ADDENDUM NO. 4

NOVEMBER 11, 2026

CITY OF HIGHLAND VILLAGE

HIGHLAND SHORES BOULEVARD
RECONSTRUCTION PROJECT
From Twin Coves Drive/Hillside Drive to 200'± West of Lake Cove

HIGHLAND SHORES BLVD PAVEMENT SECTION

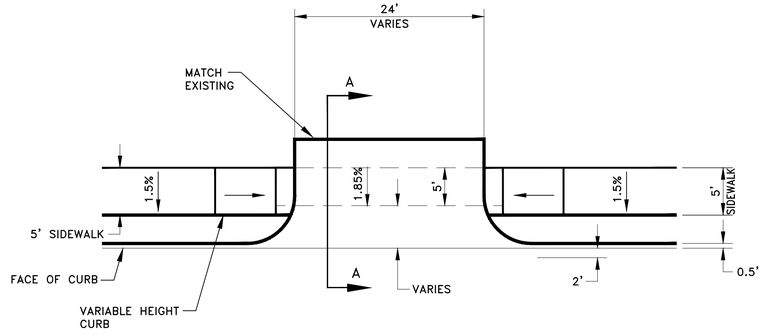
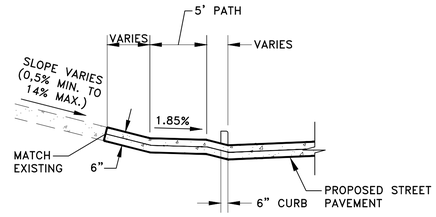
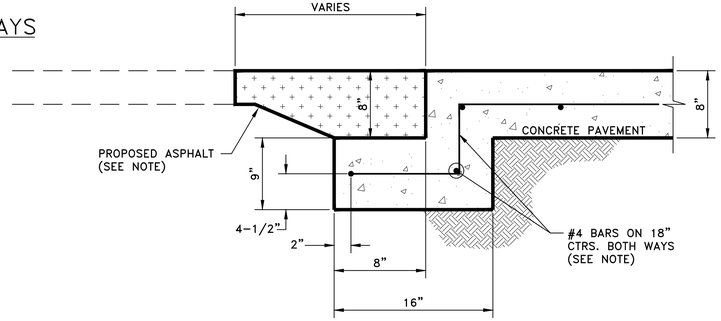
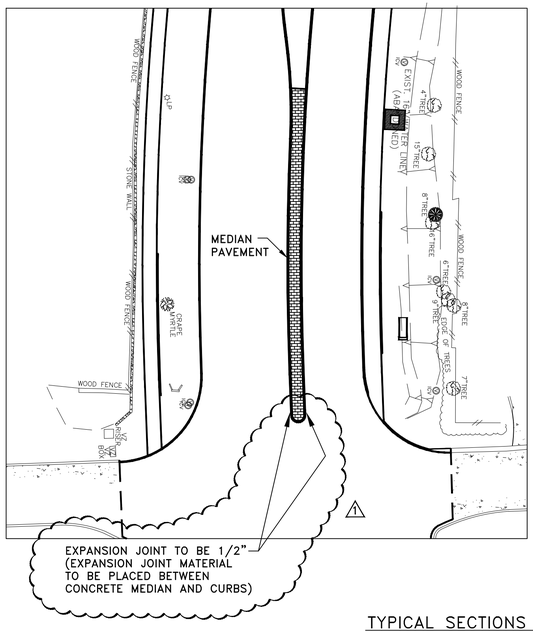
6. Replace Construction Details Sheet No. 5 with Attached Sheet.

4. ⚠1 IN LUE OF 8" CEMENT TREATED BASE CONTRACTOR MAY USE 8" THICK AGGREGATE BASE. AGGREGATE BASE SHALL BE TXDOT TYPE A OR TYPE D AND MEET TXDOT ITEM 247 GRADE 1-2. AGGREGATE BASE SHALL BE COMPACTED IN 4" TO 6" COMPACTED LIFTS TO A MINIMUM OF 95% OF THE MAXIMUM STANDARD PROCTOR (ASTM D698). ADDITIONAL EXCAVATION OF EXISTING EXCESS 8" MATERIAL SHALL BE SUBSIDIARY TO 8" THICK AGGREGATE BASE.

DETOUR PLAN

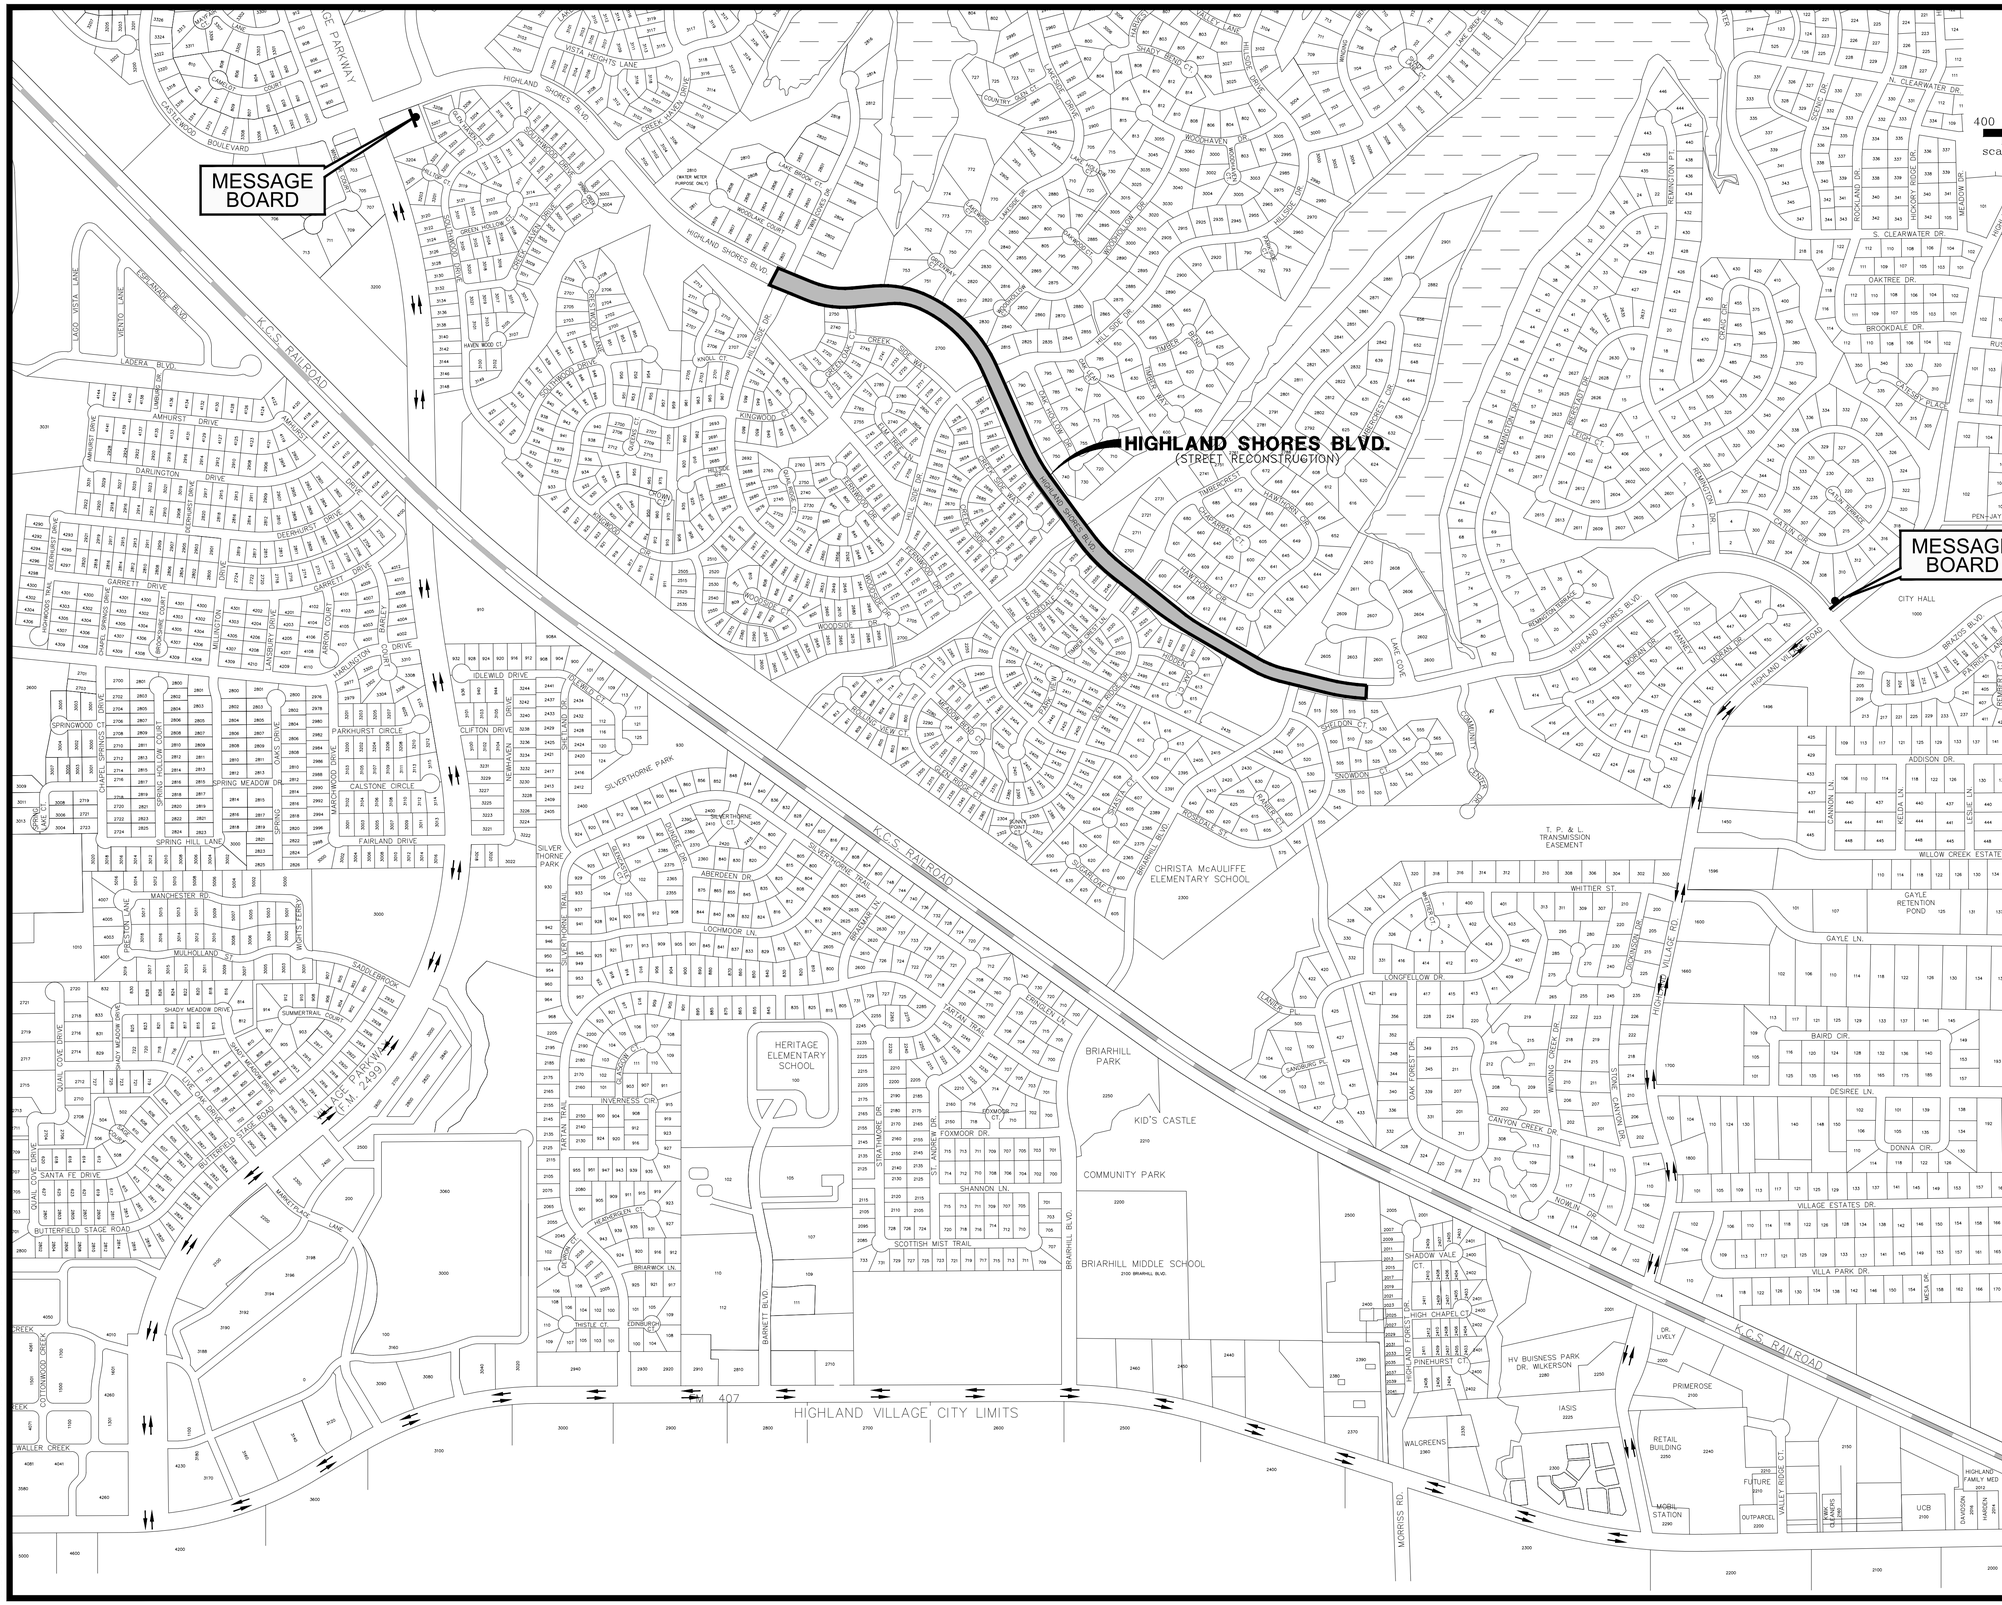
7. Replace Detour Plan Sheet No. 26 with Attached Sheet.

NO.:	DATE:	REVISION:	REVIEWED:
7			
6			
5			
4			
3			
2			
1	11/11/26	DETOUR SIGNS REMOVED	JDW

HIGHLAND SHORES BOULEVARD RECONSTRUCTION PROJECT
(FROM TWIN COVE DRIVE/HILLSIDE DRIVE TO 200'± WEST OF LAKE COVE)
SIDEWALK "A" - PLAN AND PROFILE
STA. 32+00 TO STA. 36+00
CITY OF HIGHLAND VILLAGE

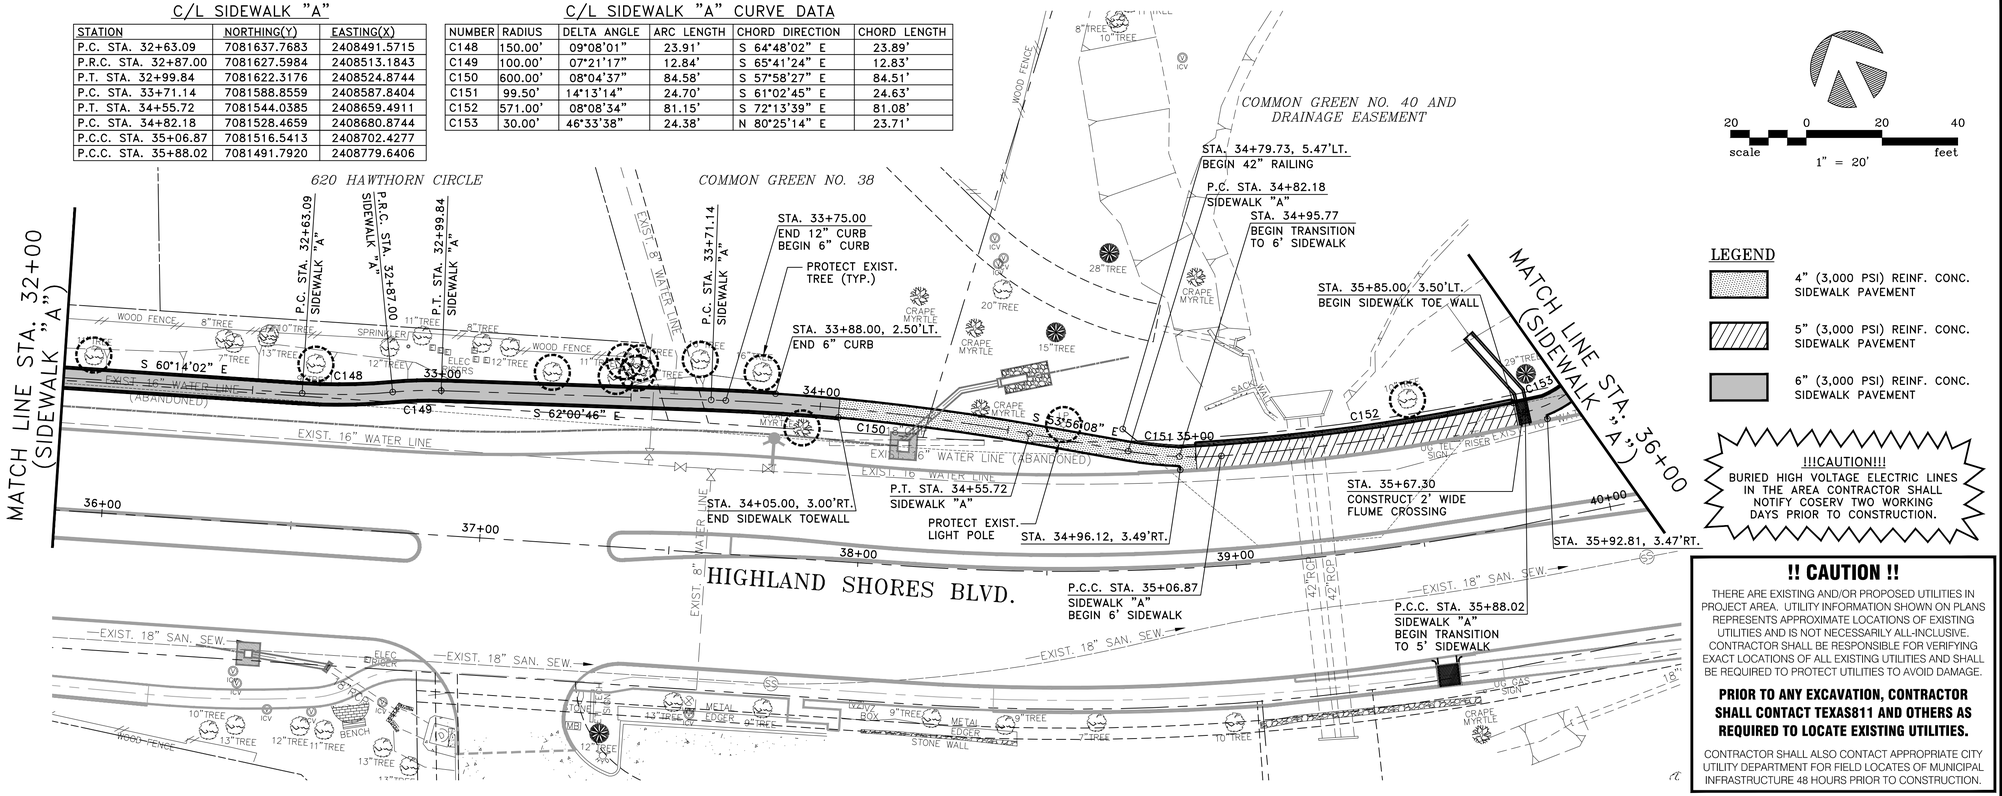
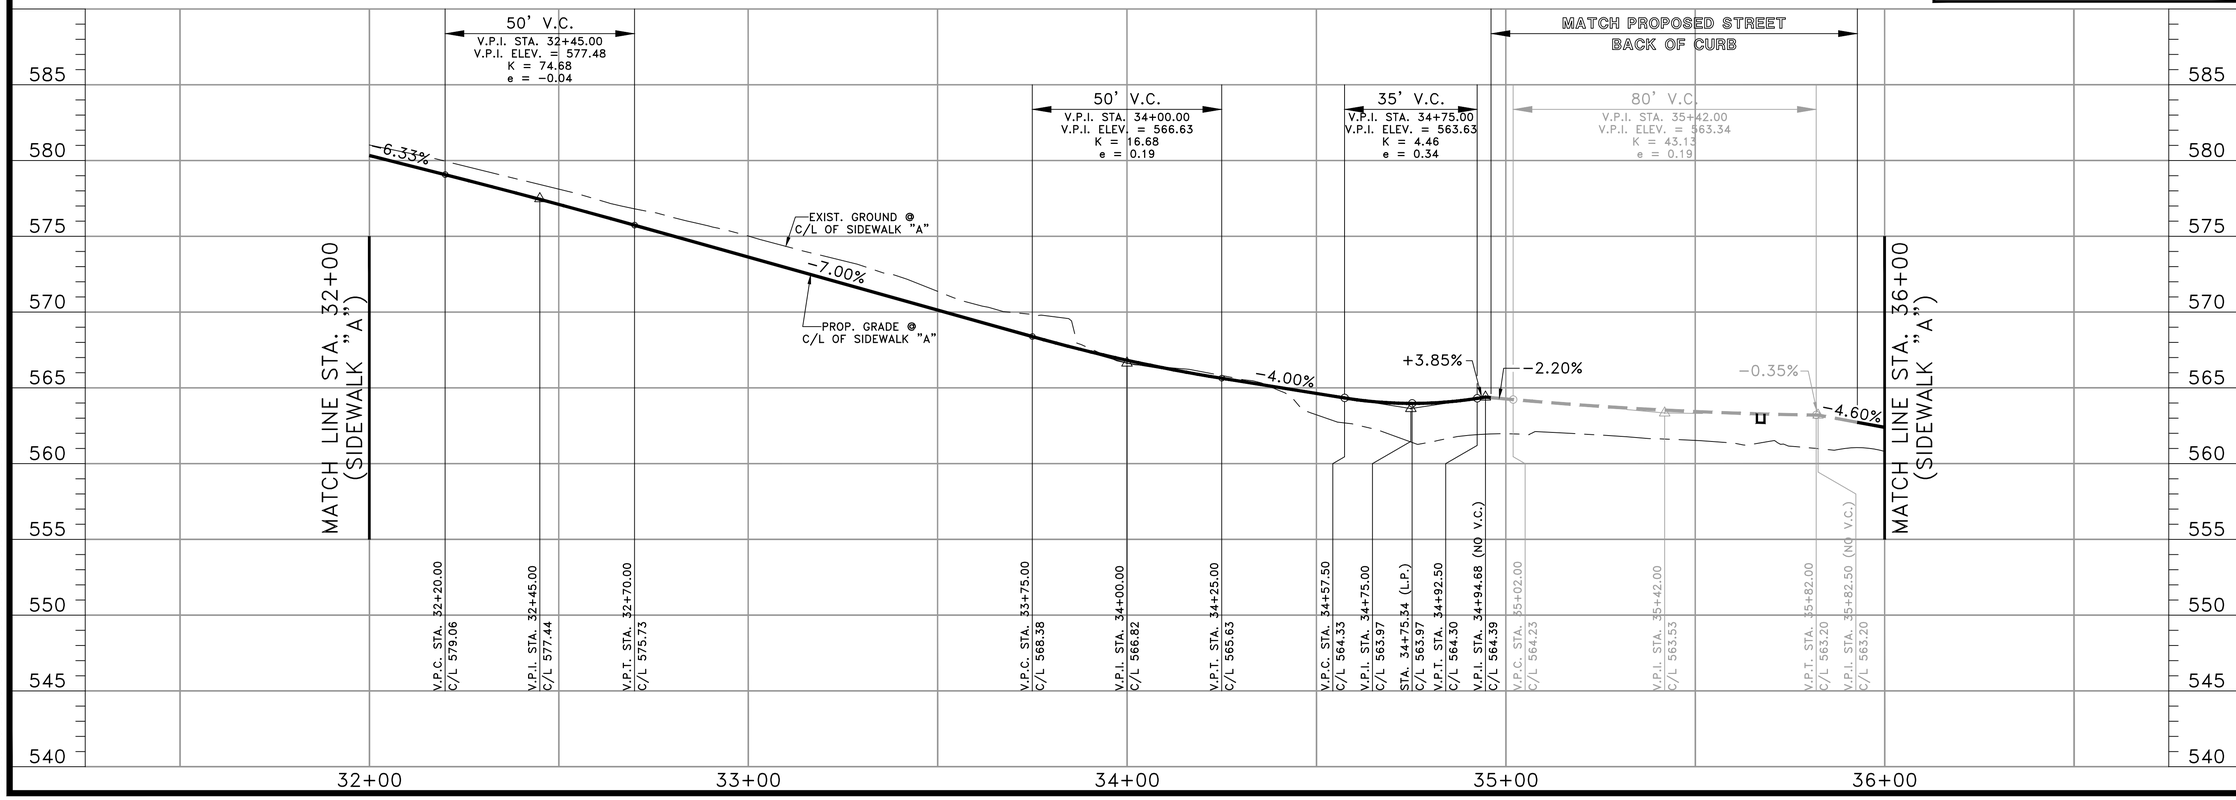
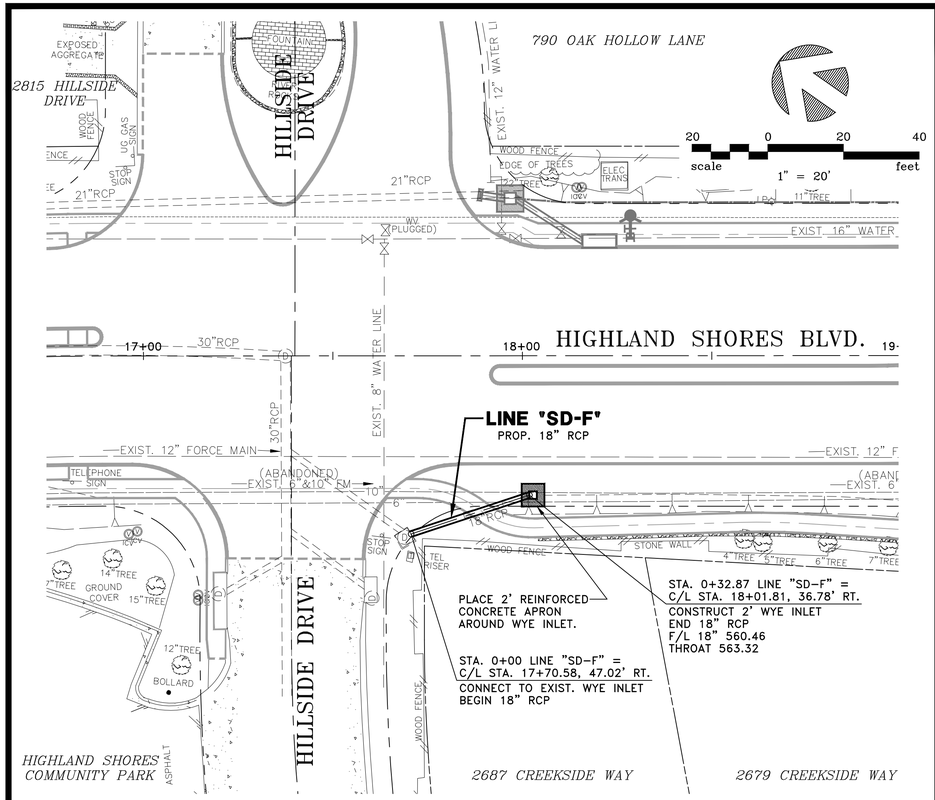
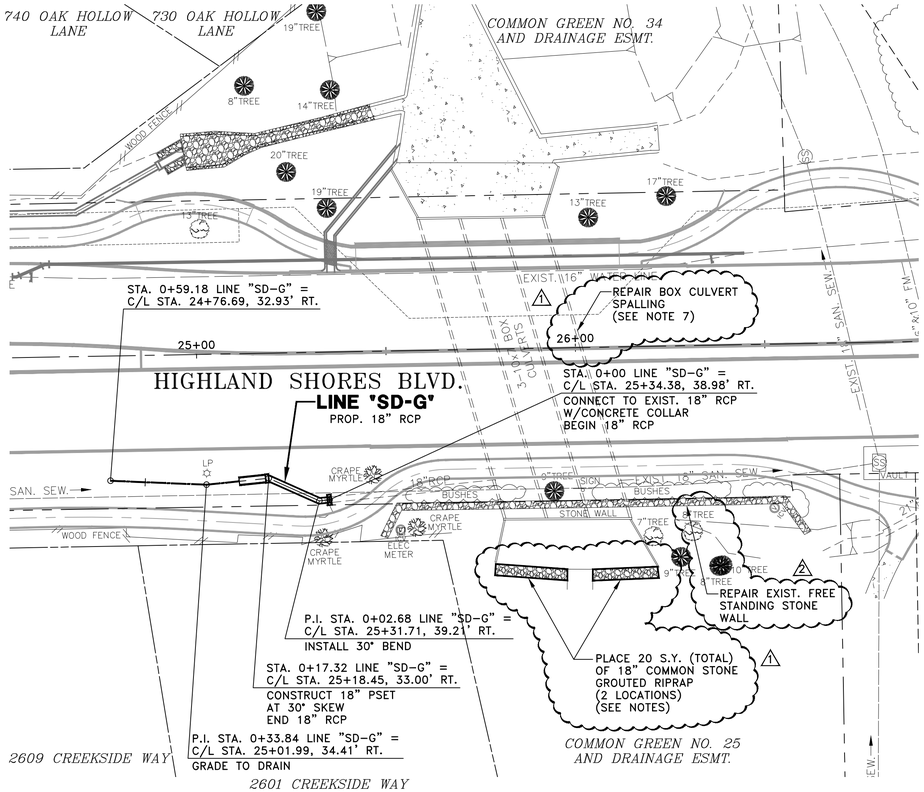
8. Replace Sidewalk 'A' Plan and Profile Sheet No. 81 with Attached Sheet.

NO.	DATE:	REVISION:	REVIEWED:
6	11/11/26	FILL WALL REMOVED	JDW
5			
4			
3			
2			
1
